Sheet: /Buttons\_indication/  
File: Buttons\_indication.kicad\_sch

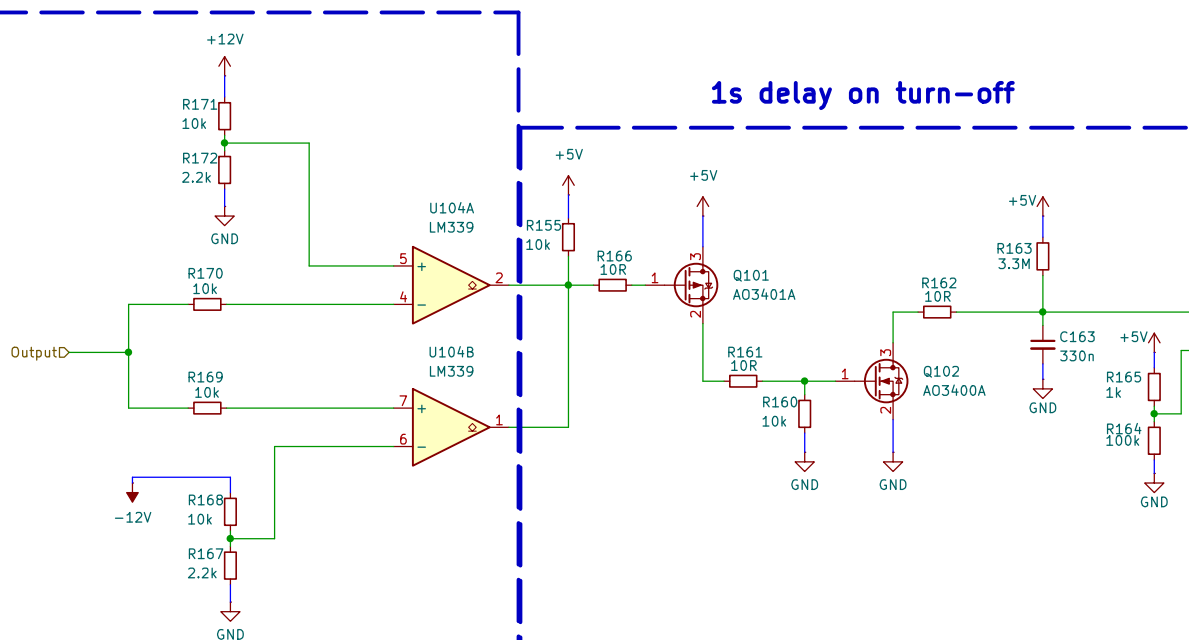
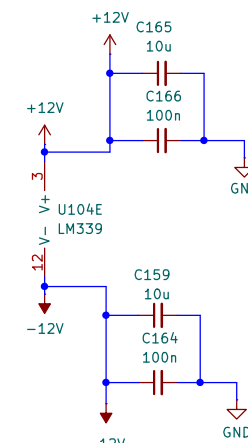
Q101 - reverse D with S...  
R165 -> 10k  
R163 -> 1M
